Docket No. 52-021
MHI Ref: UAP-HF-10019

Subject: MHI's Responses to US-APWR DCD RAI No. 493-3983

Response to Request for Additional Information No. 493-3983,
Revision 1

RAI NO.: NO. 493-3983 REVISION 1
SRP SECTION: 03.07.03 - Seismic Subsystem Analysis
APPLICATION SECTION: 3.7.3
DATE OF RAI ISSUE: 12/01/2009

Figure 1 Comparison of RCL Model

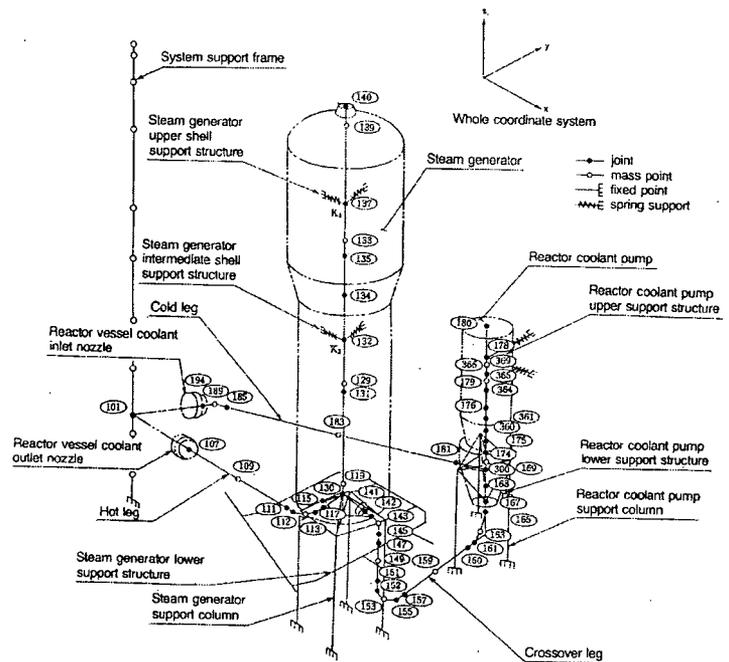
In response to RAI 3.7.3-14, the applicant refers to a verified standardized modeling methodology to confirm the adequacy of the number of discrete mass degrees of freedom for the reactor coolant loop subsystem model. Describe this methodology, describe what key features of the methodology were incorporated in the analysis and design of standard plant and discuss how the modeling methodology compares with the modeling guidelines of the SRP.

Regarding the response to RAI 3.7.3-14, describe the relevance of the benchmarking data presented in the 1989 ASME PVP proceedings to the modeling of the US-APWR. Is the benchmark data intended to demonstrate the validity of the general MITI methodology? Is it because the configuration of the PWR RCL is similar to the USAPWR design that the benchmarking validates the modeling of the US-APWR RCL?

The part of the Loop-A model of the US-APWR RCL extracted from the technical report MUAP-08005 Rev. 0¹⁾ is presented in the left-side figure, while the standardized loop model of the Japan PWR plant is in the right-side figure. These loop models are constructed under the common modeling methodology described above. The appropriateness of the standardized loop modeling and response analysis method was proved by the seismic proving test of NUPEC PWR Primary Coolant Loop System^{2), 3)}.

The US-APWR is a four loop plant. Each RCL consists of the reactor vessel (RV), the steam generator (SG), the reactor coolant pump (RCP), and the loop piping. The loop piping consists of hot leg, cross over leg, and cold leg piping. These basic configurations are common for the Japan PWR RCL. Although the length, the size or the weight of each component or piping are different, the methodology to develop the lumped-mass stick model of the RCL subsystem is thought to be common to the Japan PWR RCL, as presented in Figure 1 of the answer to RAI 03.07.03-3. For example, the comparison of the number of the nodes between US-APWR RCL model and the Japan PWR RCL model is presented in the following table.
